October 4, 2018

McDonald's

5324 4th St NW Albuquerque, NM

Traffic Circulation Layout

SITE & PAVING

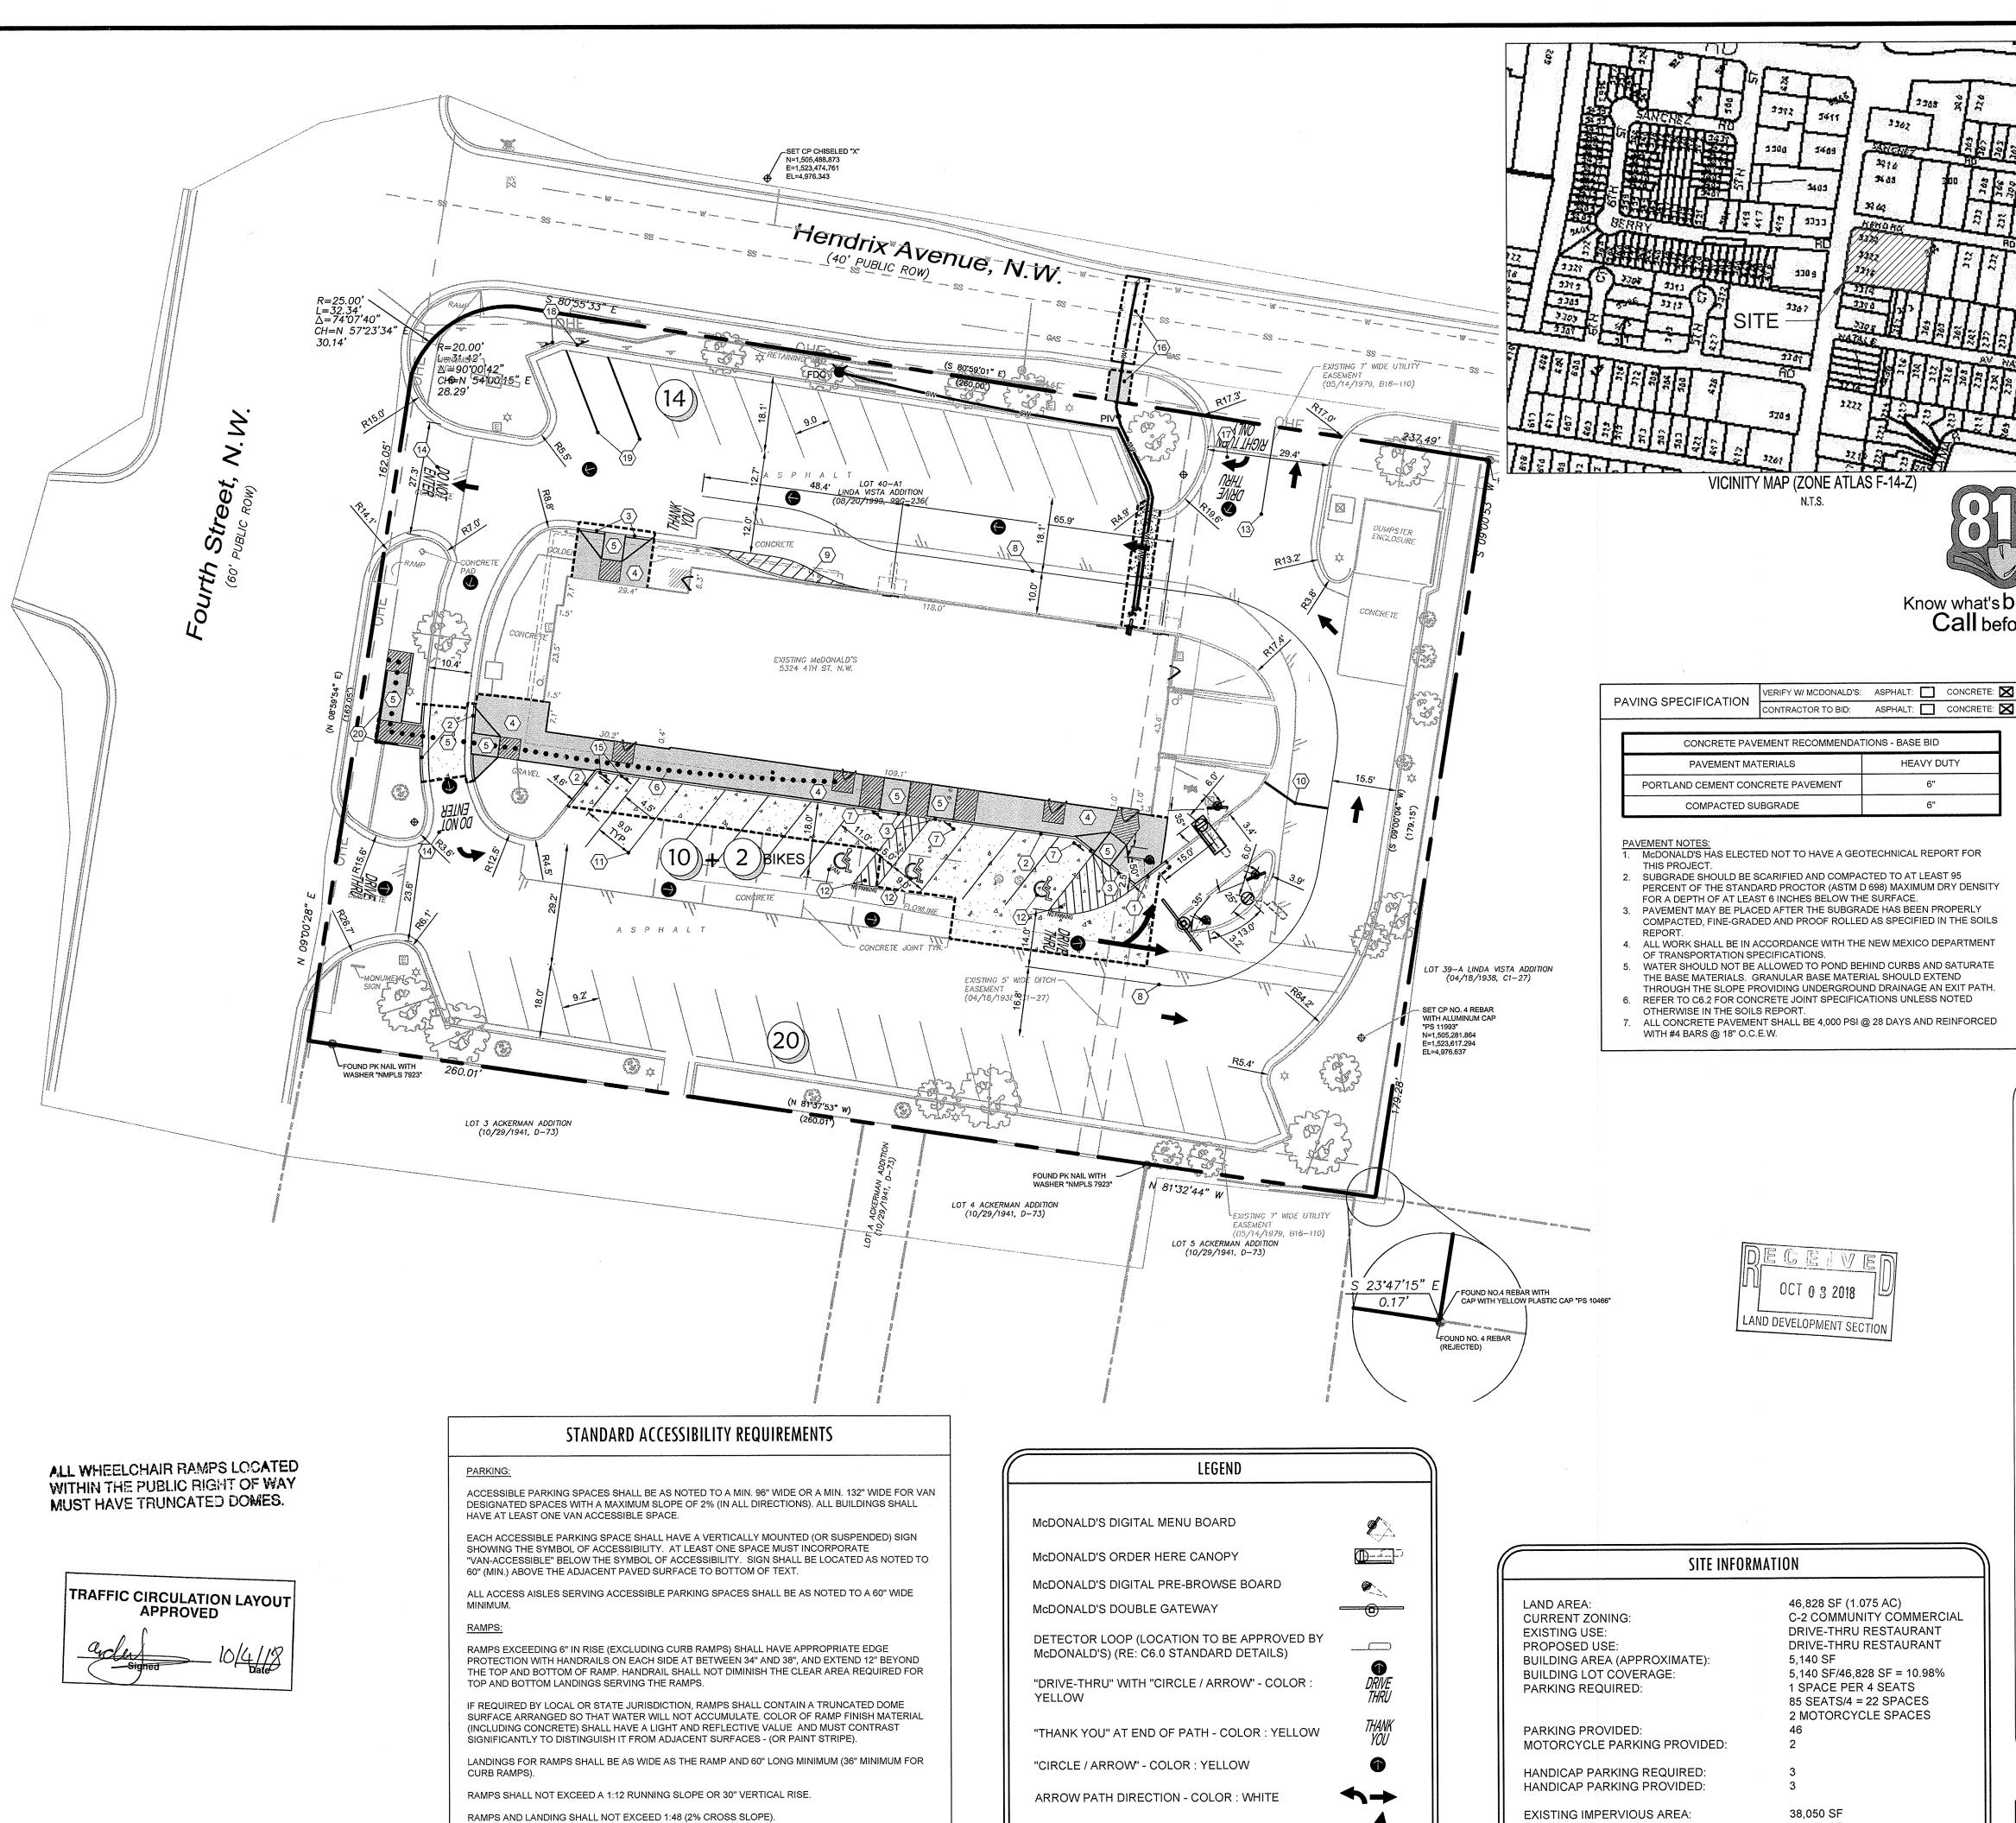
The TCL submittal received 10-03-18 is approved for Building Permit. A copy of the stamped and signed plan will be needed for each of the building permit plans. Please keep the original to be used for certification of the site for final C.O. for Transportation.
